CAPRICORN MUNICIPAL DEVELOPMENT GUIDELINES

2023 MEETING 2 MINUTES

Date and Time: 30th March at 10:00 am

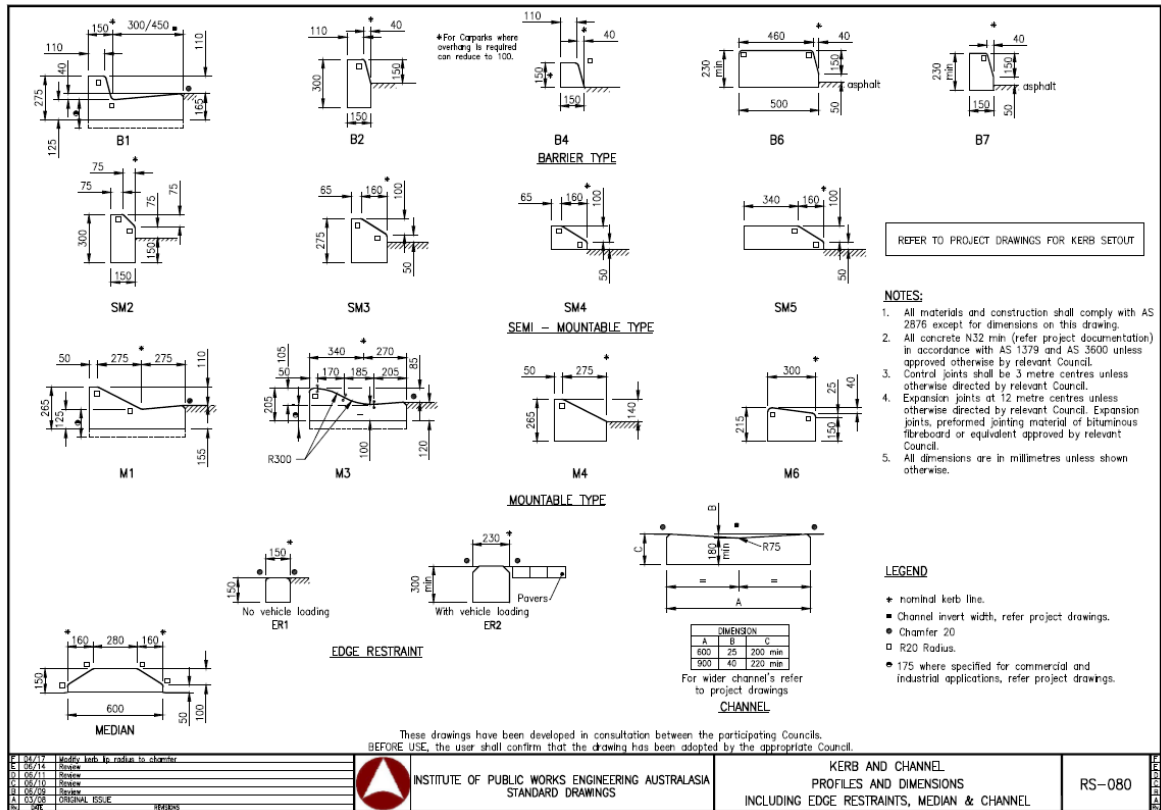
M2023.02 discussion

Discussion on whether to keep table or convey information in a different way. The main issue to convey was that the CMDG Table D05.16.1 was intended to convey requirements for Low density residential and not other development.

Update Table D05.16.1:

- Add “Low density residential” to the QUDM Level title followed by (Note 3).

• Add “low density residential only” after the No grated inlets. • Add extra column – Application. Column entry to be “Low density residential” for all LGAs except GRC where the column entry is to be “residential” • Note 3 – For all other development categories – industrial , high density residential, commercial etc refer to QUDM. <u>Action By</u> MCE
--	--

The key difference between the drawings W-090 and W-090A is the water service connection detail:

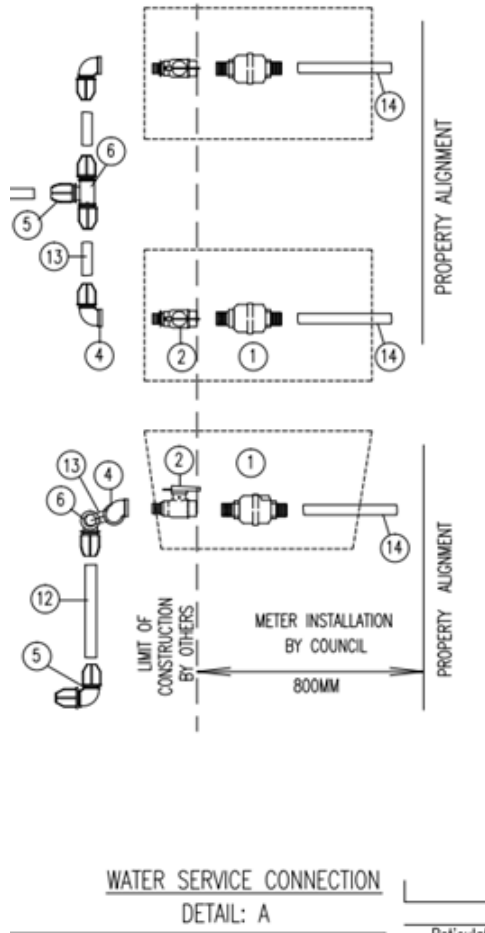
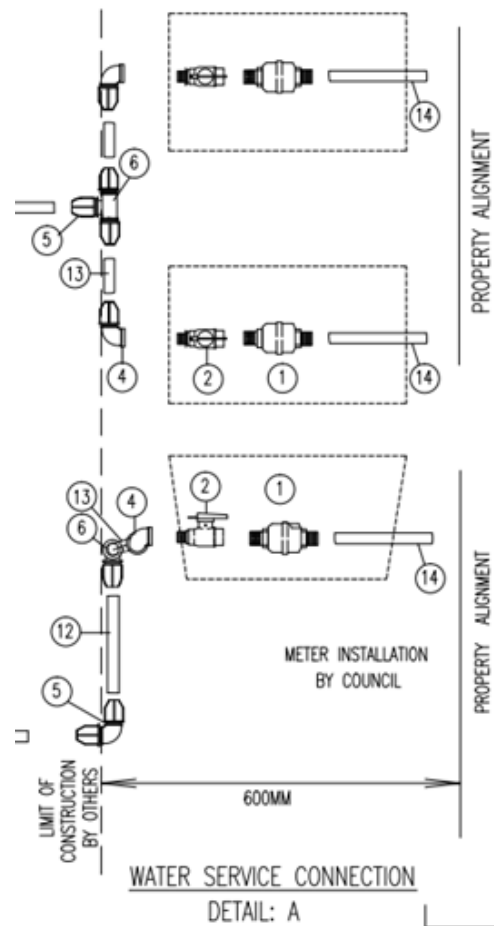
As part of an update to W-090 it was noted that the differences between W-090 and W-090A are minor and there may be an opportunity to combine them.

The other difference between the drawings is just the short single size on the W-090A is 25mm not 32mm, this could be covered in the applicability table if required.

The main benefit from not installing the valve is reduction in the risk of water theft.
